**ISSUE:** Certificate of Appropriateness for New Construction

**APPLICANT:** PT Blooms, LLC, contract purchaser

**LOCATION:** Old and Historic Alexandria District  
805, 809, 811, 815, and 823 North Columbus Street

**Certificate of Appropriateness Reviews**

**Figure 7: Site section showing proposed building with hotel and existing residential structures**

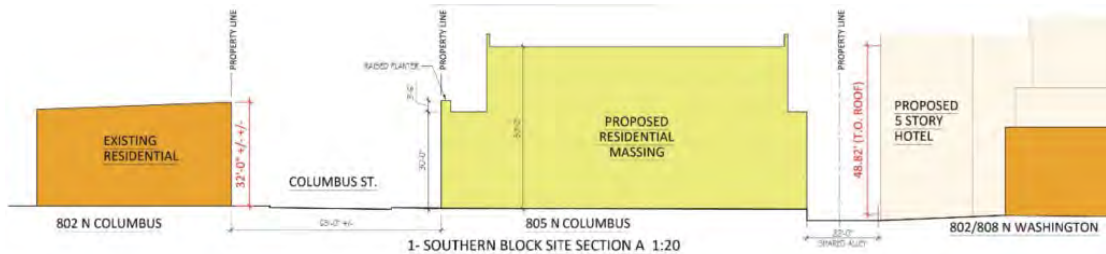
The *Design Guidelines* further state that “Multi-family structures such as apartment buildings often exceed the prevailing height of single-family houses. Such structures may be constructed to the maximum permitted height by zone but should not overwhelm adjacent buildings.” The hotel currently under construction immediately to the east of the site will be approximately the same height as the taller, eastern, portion of the proposed building. The houses on the west side of South Columbus Street range in height but are approximately 30 feet tall at the sidewalk edge. This is the approximate height of the three-story section of the building directly adjacent to North Columbus Street (Figure 7). Staff finds that the proposed massing of the building appropriately

transitions from the small scale residential neighborhood to the west of the site to the more large scale building facing Washington Street to the east. Given this transition, the proposed project will not “overwhelm adjacent buildings.”

**Figure 9: Enlarged plan showing area of transition between exterior materials**

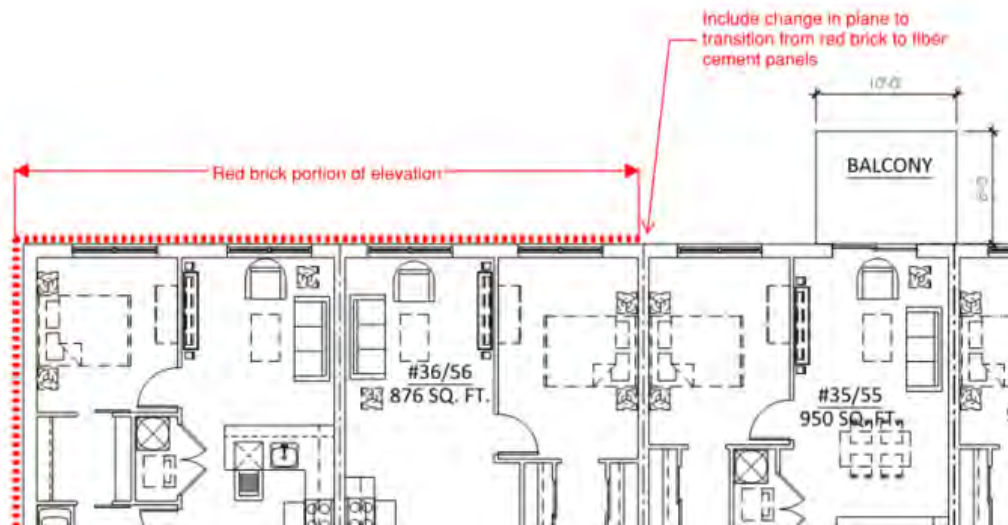
One thing that is not clear from the submitted drawings is how the architecture of the lower portion is terminated on the east elevation. Per the plans included in the submission, there is no change in plane where this transition is made (Figure 9). Staff recommends that the applicant work with staff to include a reveal or other change in plane at this transition to allow for the change to be made at an inside corner.

1. The applicant work with staff on the design and detailing of the building entry doors.
2. The applicant work with staff on the size and design of the balconies on the east elevation.
3. As the design progresses, the applicant work with staff on the final detailing for the black metal clad portions of the building.
4. The applicant work with staff to introduce a reveal or other change in plane at the east elevation where the red brick portion of the building changes to the fiber cement portion to allow the material change to occur at an inside corner.
